AXC F 2152 – CHANGE NOTES

Change notes for the AXC F 2152 controller

108427_en_20

This document contains all changes made between firmware version 1.0.0 and the current firmware version of the AXC F 2152 controller (Order No. 2404267).

Left-alignable INTERBUS master

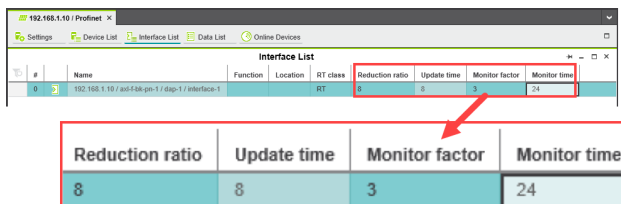
The controller now supports left-alignment of the INTERBUS AXC F XT IB master (Order No. 2403018).

Figure 2 Select Trigger task

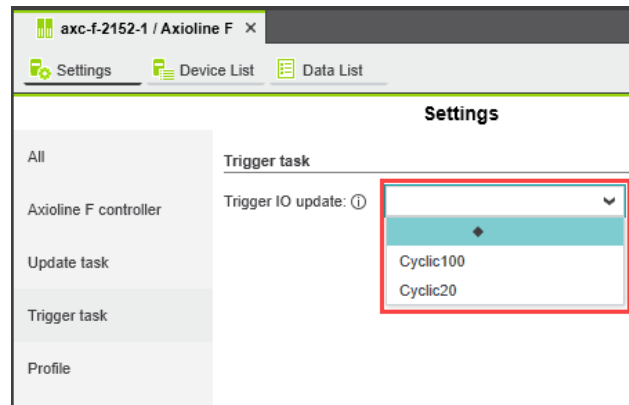
- Select the “Trigger task” view in the “Settings” editor.
- In the drop-down list, select the task that is to trigger the Axioline F I/O data update.

If you do not select a task, the update will occur by default every 50 ms.
